PRELIMINARY PLAT AMENDMENT

STAFF REPORT

ARIA PHASE 4

May 18, 2021
20-67PP

Preliminary Plat Amendment (Approved Compared to Proposed)

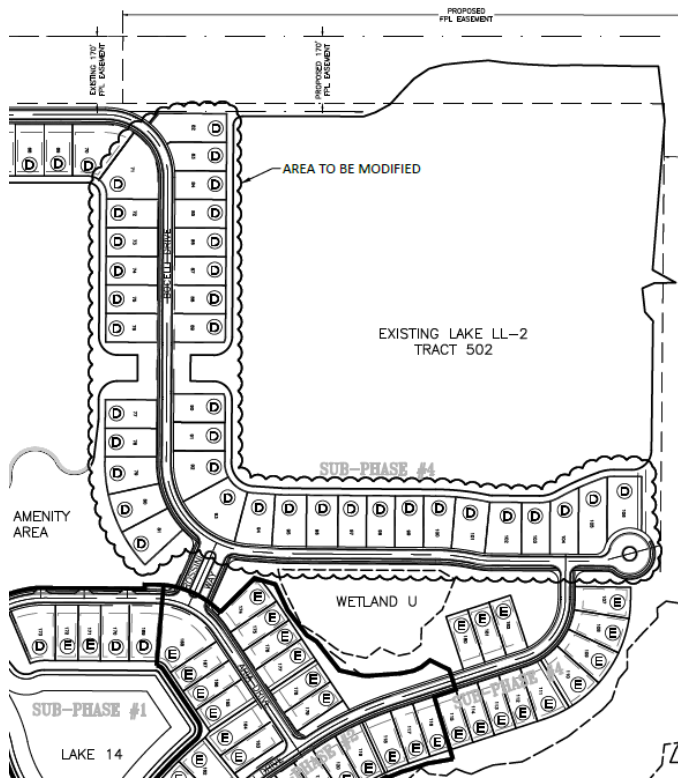
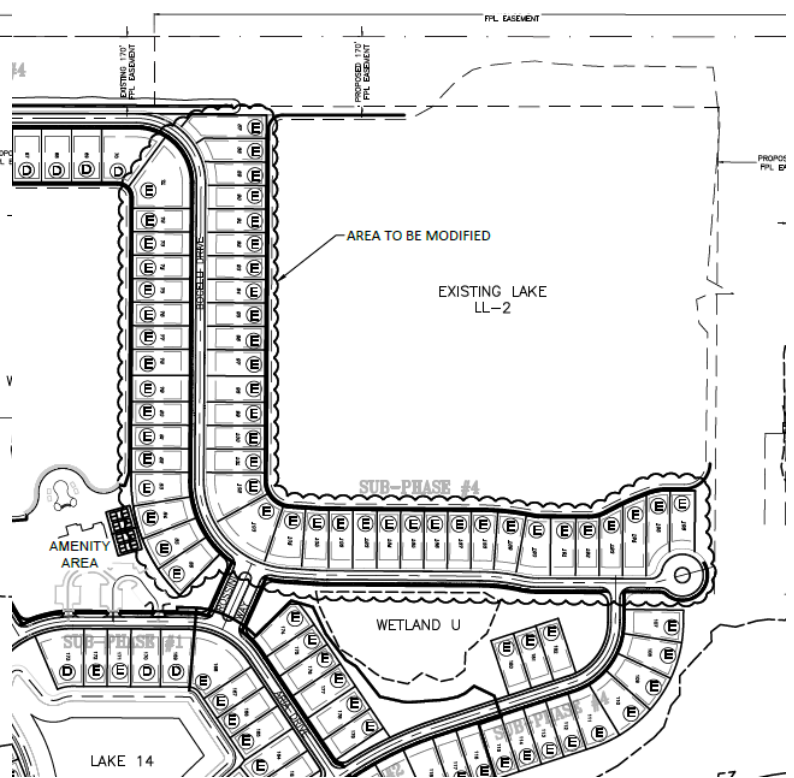
The subject property is in Phase 4 of Aria, a portion of the Milano PUD. The preliminary plat amendment request for Aria proposes to change lot sizes along a portion of Bocelli Drive from 72'x130' (Lot Type D) to 57'x140' (Lot Type E). Making these lots narrower will also allow for the creation of 14 additional lots on Bocelli Drive. The PUD allows for 1350 lots, for a density of 2.56 dwelling units per acre, and currently there are 831 platted lots in the development. This plat would bring the total number of units to 845, well below the total allowed.

Small changes will be made to the configuration of neighboring ponds, designated on the plat as Lake LL-1 and Lake LL-2. These ponds are proposed to decrease in size by 0.5% and 1.7%, respectively, to accommodate the longer Type E lots. Stormwater infrastructure changes will be needed as well, including adjustments to the water mains and sanitary sewer mains and to the location of the existing storm piping system. The applicant notes that water services have not yet been installed in this area.

TYPICAL LOT DETAIL
SINGLE FAMILY DETACHED
MIN LOT AREA = 9000 SF

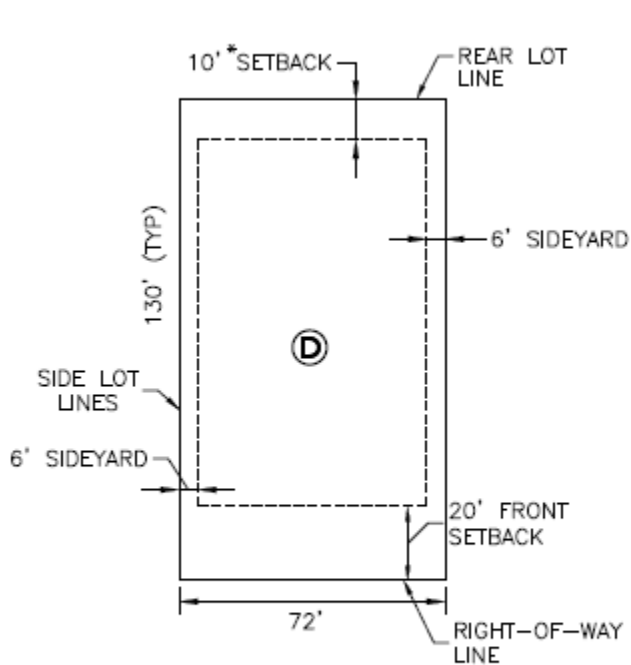
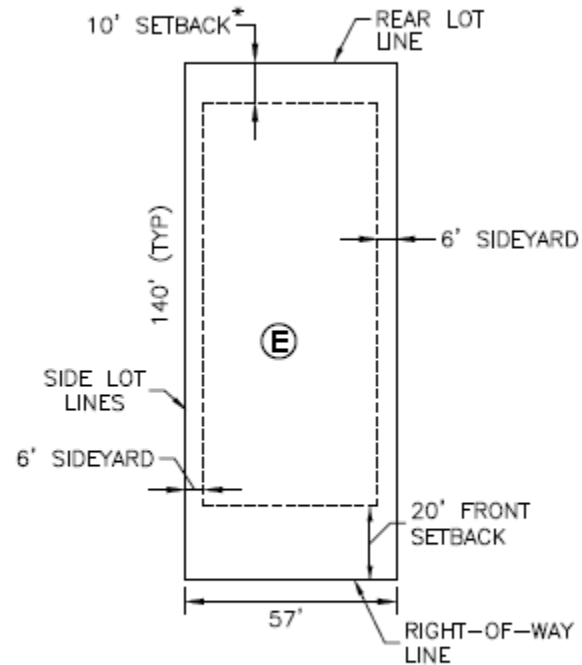
The minimum lot size for single family detached lots in the Milano Binding Master Plan is 4,500 square feet; the fifty proposed Type E lots will have a typical area of 7,980 square feet (with a minimum of 7,500 square feet

noted on the lot typical detail). Changes to open space will be negligible, with the lakes changing by 0.5% and 1.7% each. Open space in the PUD is currently at least 55.2%, at the time of the latest amendment to the development (petition no. 20-05PP – Fiore). The requirement in the Binding Master Plan for open space is a minimum of 50%, and the stormwater changes proposed through the subject petition will not change the land use distribution by enough to cause issue with this requirement.
